SUBJECT: Approval of Review Plan for a Request, Pursuant to 33 USC § 408, to Alter the Red River Backwater Project Tensas-Cocodrie Area Levee by Installing a Box Culvert to Allow Brushy Bayou to Drain into the Tensas River

REVIEW PLAN for
Construction of Proposed Brushy Bayou Drainage Structure
Pursuant to 33 USC § 408
Vicksburg District

DESIGN AND CONSTRUCTION PHASE REVIEWS
BRUSHY BAYOU DRAINAGE STRUCTURE
CONCORDIA PARISH

Figure 3 – Observed Stages vs Calibration Profile

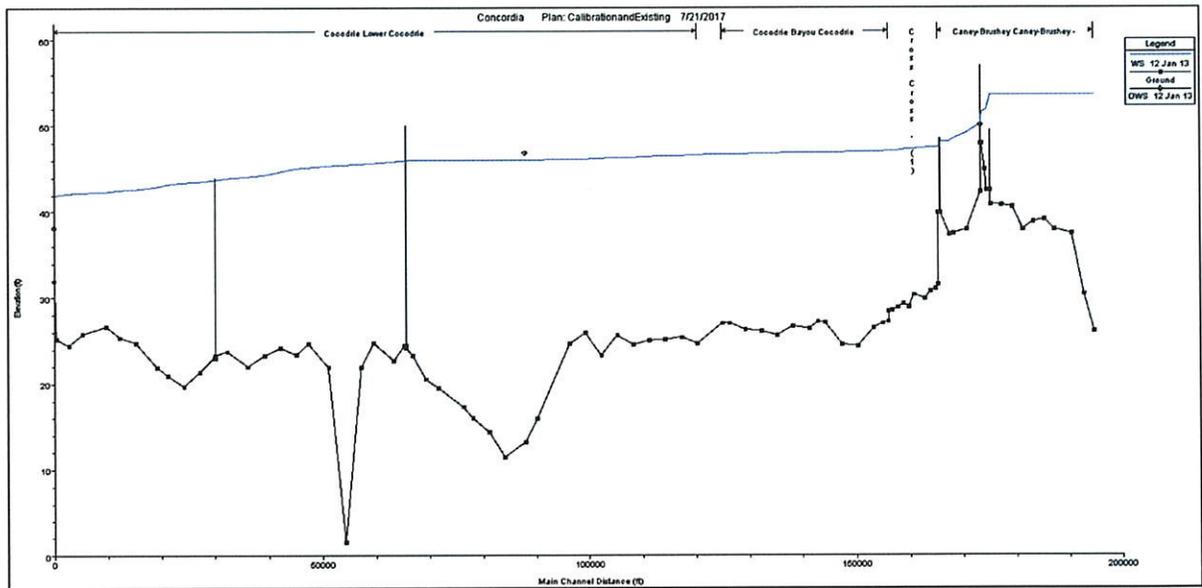
7. Page 11, Show calibration profiles verses observed stages.

Response: Show calibration profiles verses observed stages. See Figure 3 below. Observed levels are shown as circled dots on the graph as they were isolated observation points, i.e. complete water surface profiles were not collected or available.

Reply: Ok

Figure 4 - Caney and Brushy Bayous (Existing)

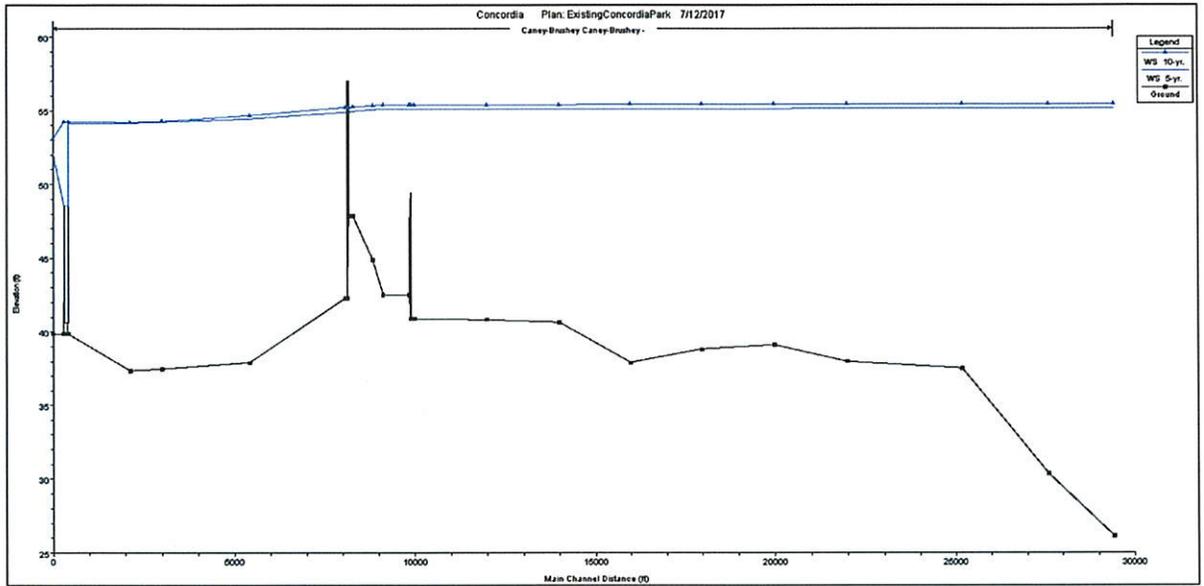
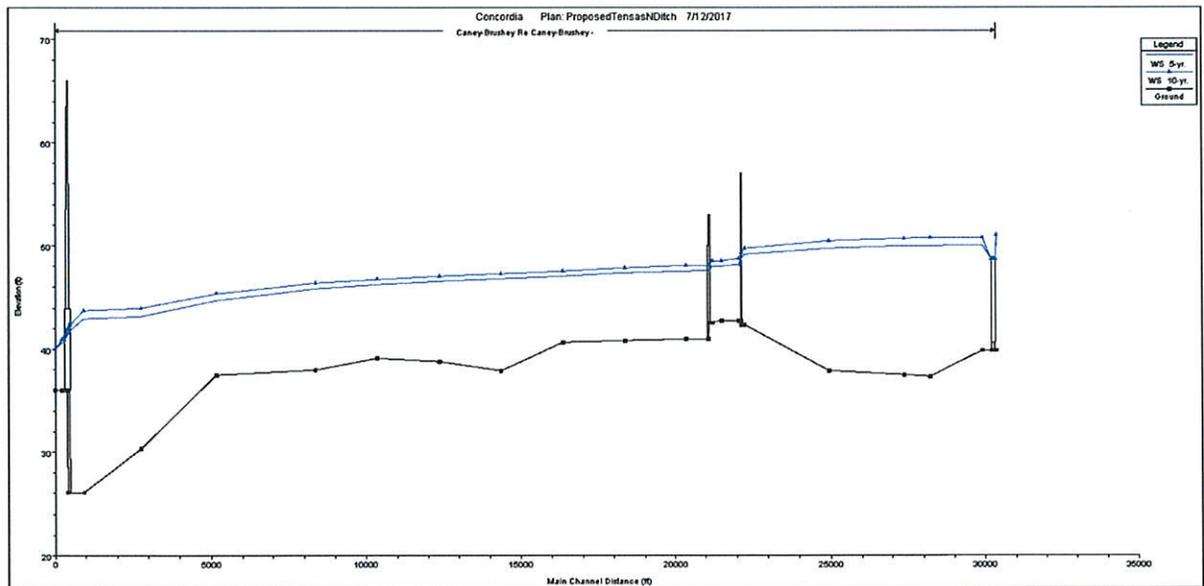
Response: Provide profiles for Brushy Bayou and Caney Bayou. See figures 4 and 5 below:

Note that as the Bayous flow in opposite directions for the two scenarios, the two profiles have reversed stationing (Existing: Left – East & Right – West: Proposed: Left – West & Right – East).

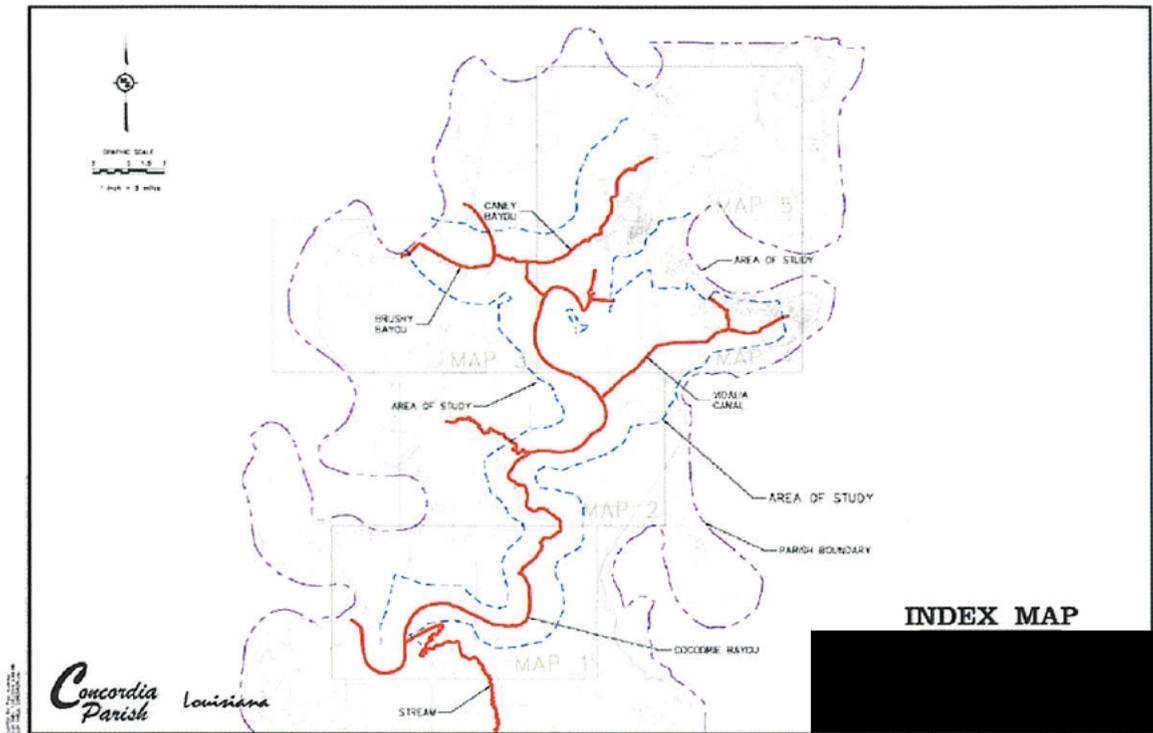
11. Page 21-30 inundation maps: The maps don't map the entire inundation area, appears to stop at a cross section width. RAS mapper should be used to map the entire inundation for each event.

Response: RAS Mapper was utilized to produce the flood extents shown on the inundation maps. The models were constructed to cover all areas necessary for the scope of the study. One area not mapped was modeled as a storage area. Other areas were determined to not contribute to the flow area and are generally just open farmland.

Further, this model does not utilize HEC-RAS 5.0's 2-D capabilities. This model was developed before HEC-RAS 5.0 was released; moreover, it is a steady state model and thus to utilize 2-D features, an unsteady model would need to be developed.
